CERTIFICATE OF APPROPRIATENESS PLACARD

410 Glenwood Ave

COA-0148-2025

Material and Detail Modifications to Previously-Approved COA

South Elevation (North St.)

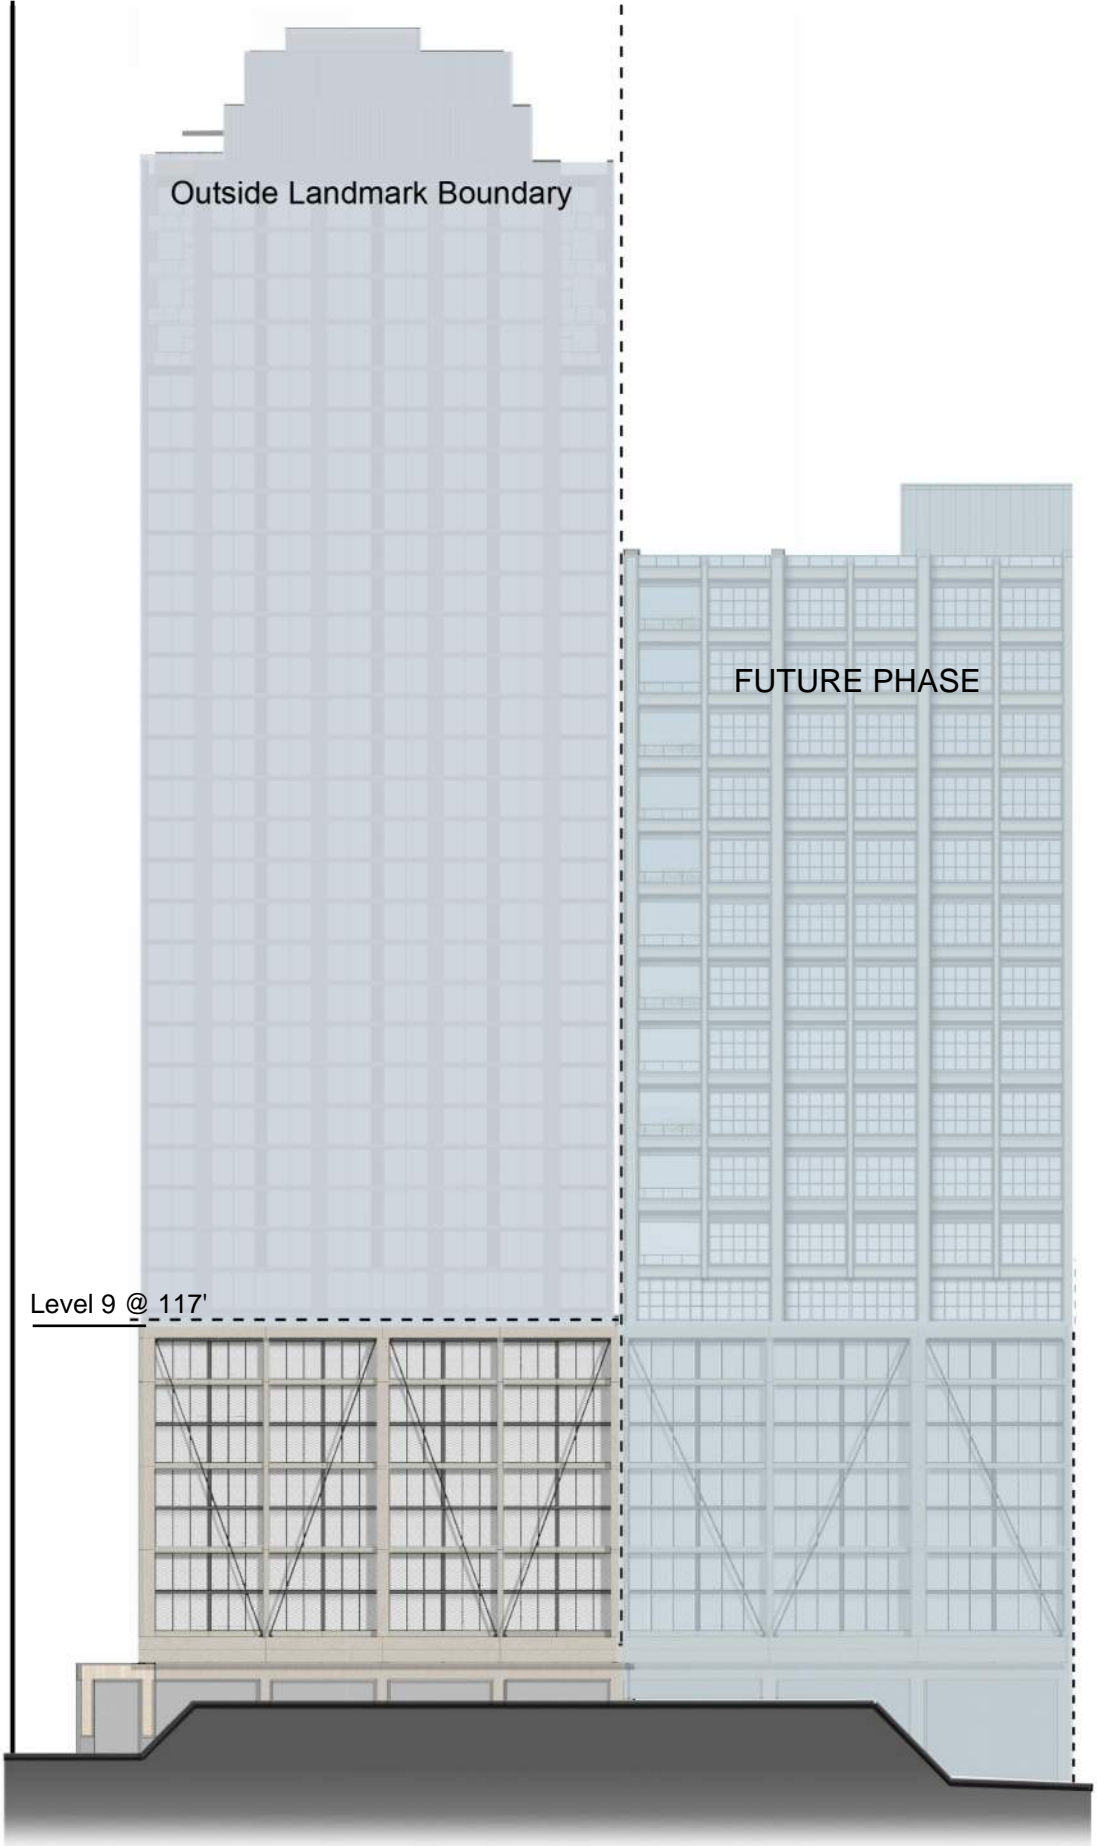
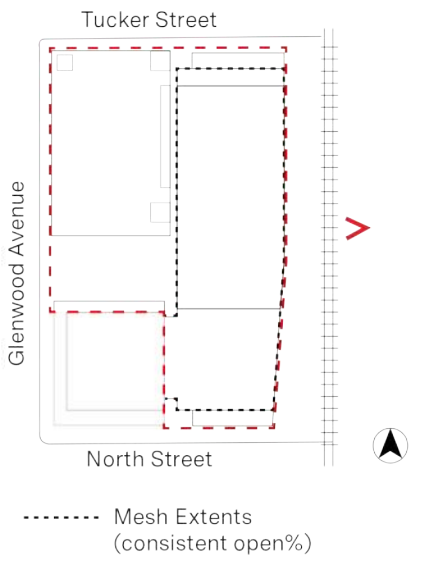
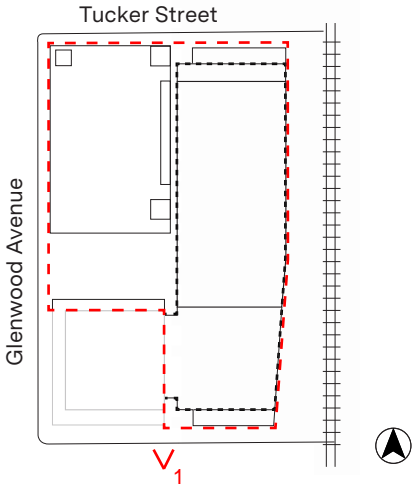
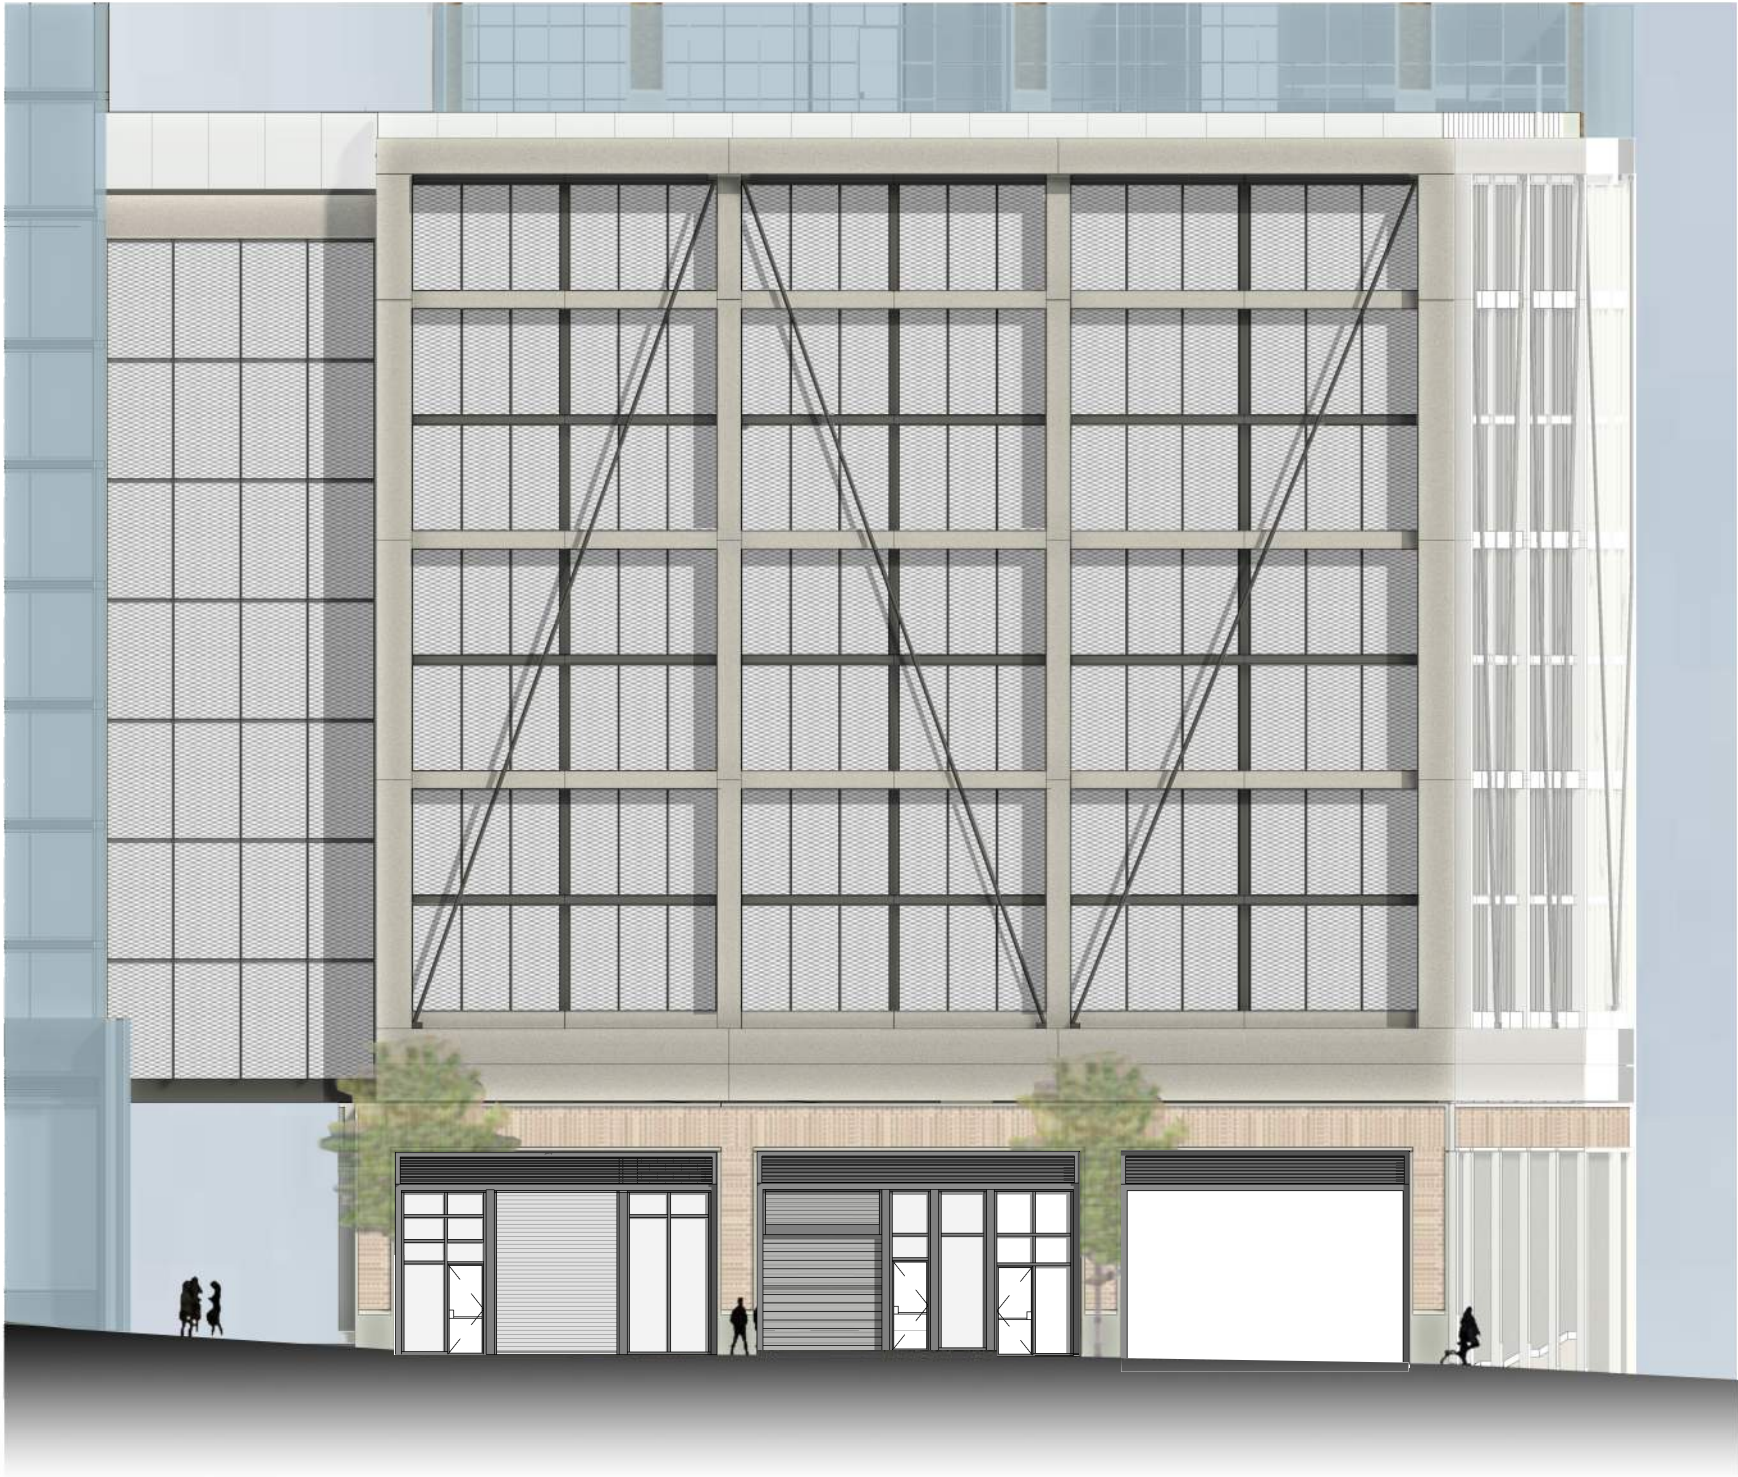
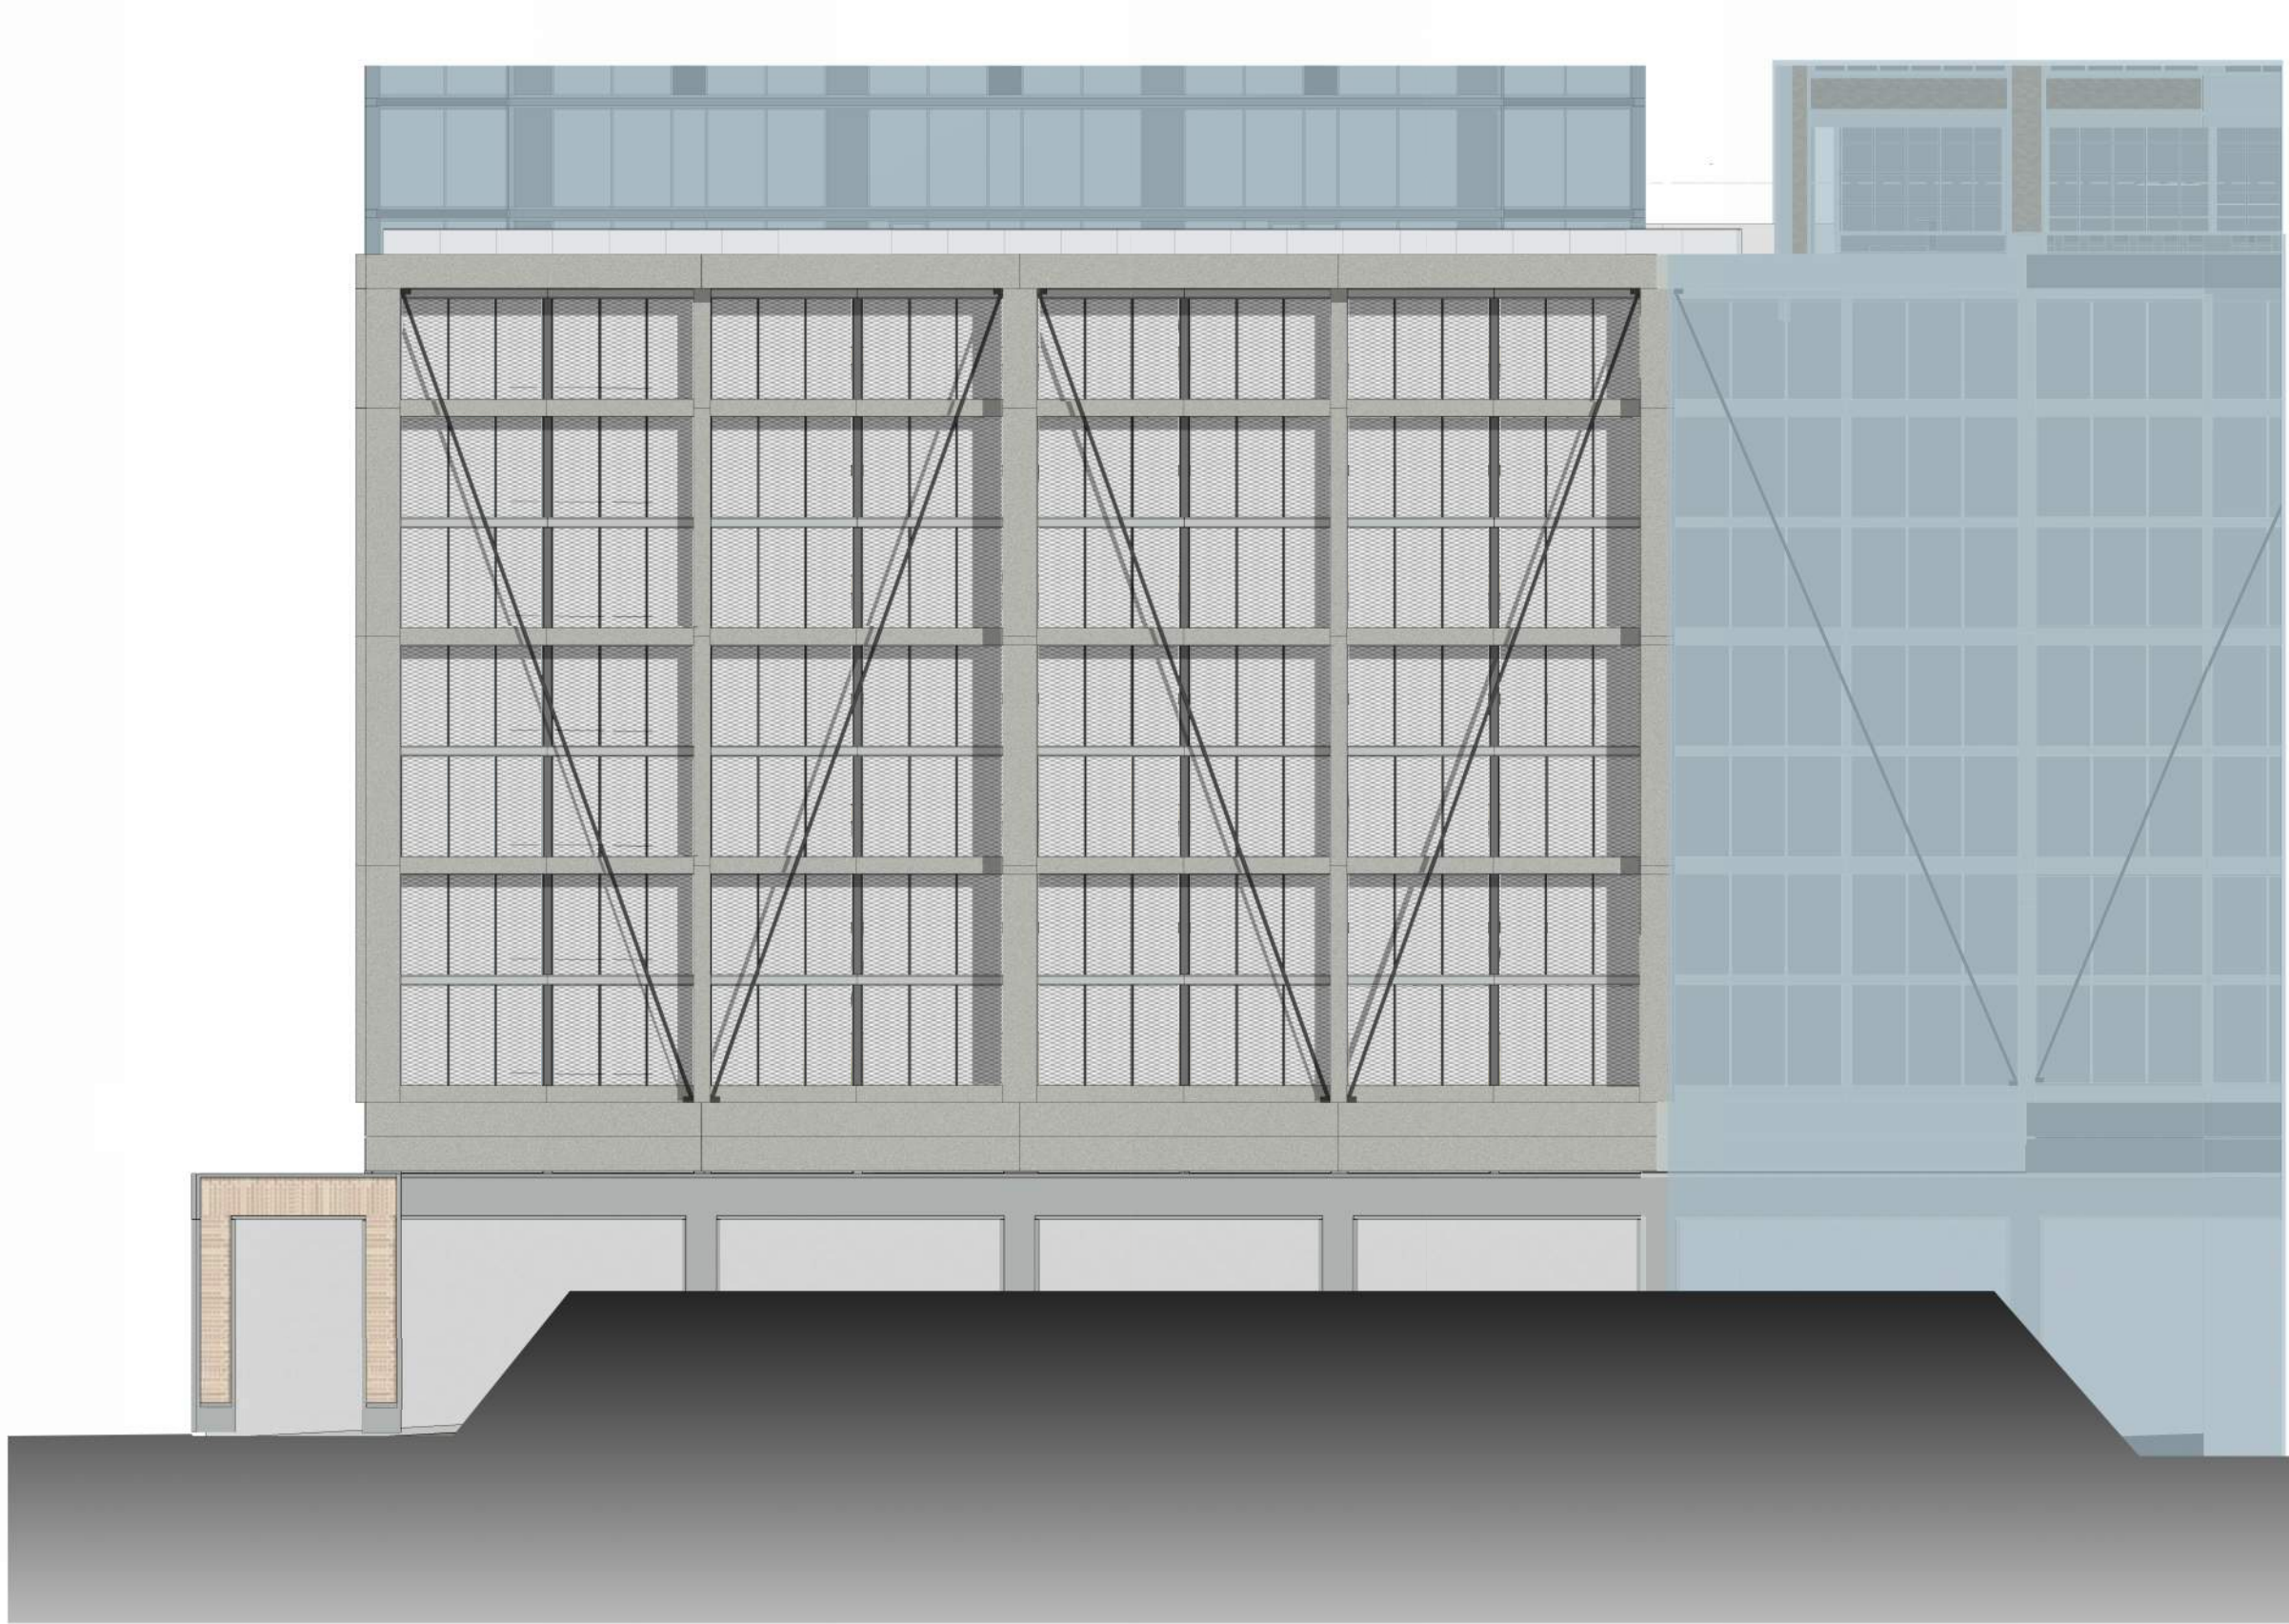
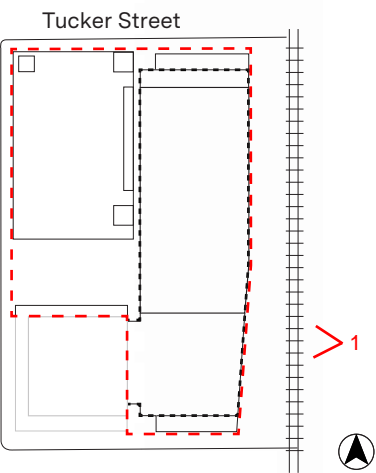
1. The previously-approved elevation included a vehicular garage entry in the east bay, utility/equipment room in the center bay, and a commercial storefront in the west bay. Based on the final engineering for the project, the center and west bays are both required to accommodate equipment and will require overhead door access.
 - The brick and concrete frame and the three associated storefront bay sizes remain consistent with the previously-approved COA.
 - The storefront elevation for these two bays has been revised to include a mix of overhead doors and storefronts in both bays to provide required service access while maintaining an equivalent amount of glazing as shown in the previously-approved COA.

1. The industrial grid has been revised from precast concrete to painted metal panel. As shown in the comparative elevations for the previously-approved and currently proposed elevations, the overall massing, dimensions, and color range of the industrial grid will be generally consistent with the previously-approved COA:
 - The rectangular profiles and widths of the grids (3'-0" for primary and 1'-6" for secondary) match the previously-approved design.
 - Due to manufacturing limitations, the proposed depth of the frame decreases from 12" to 10".
 - The 3" diameter tie rod is visually consistent with the previously-approved COA.
2. The mesh screening has been revised from expanded metal to perforated corrugated metal:
 - The level of transparency is generally consistent with the previously-approved COA.
 - The color is consistent with the previously-approved COA.

1. Side-by-side rendered elevations for the previously-approved and currently proposed elevations + enlarged elevations illustrate these modifications. *Note that the proposed elevations represent the reduction in height as approved per COA-0018-2025.*
